**ALERT SERVICE BULLETIN**

**ASB UH-1H-24-23**

**SUBJECT:** MAIN BEAM CAP ANGLE, P/N 205-030-163-093, INSPECTION OF.

**Figure1. Fuselage Tailboom Attachment Inspection.**

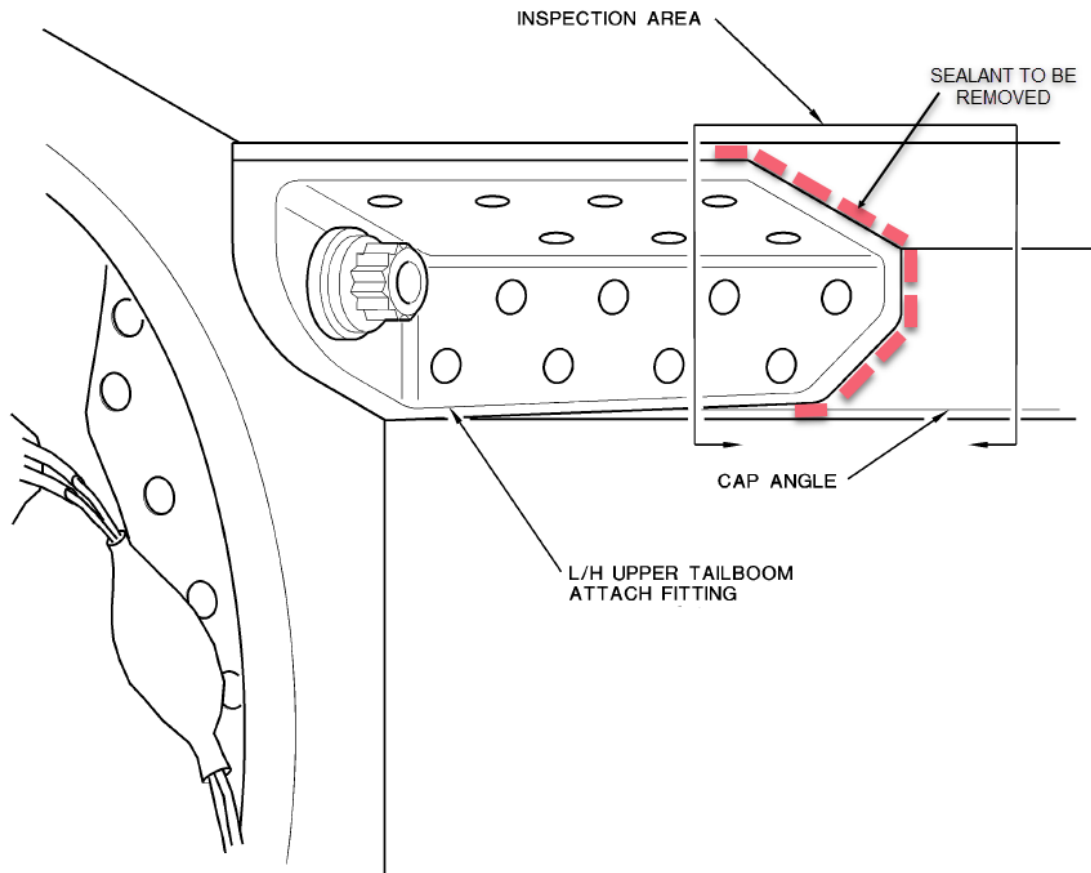
2. Remove sealant from edge of fitting (Refer to Figure 1).
3. Inspect the cap angle area shown in Figure 1 with a 10x magnifying glass and bright light.
4. If a crack is found, replace the cap angle before further flight. If no cracks are found, continue with Step 5.
5. Touch up primer and paint, if damaged during sealant removal, and allow to dry. Do not reapply sealant.
6. Ensure work areas are clean and secure. [QA]
7. Make an entry in the helicopter logbook and historical service records indicating findings and compliance with this Alert Service Bulletin.
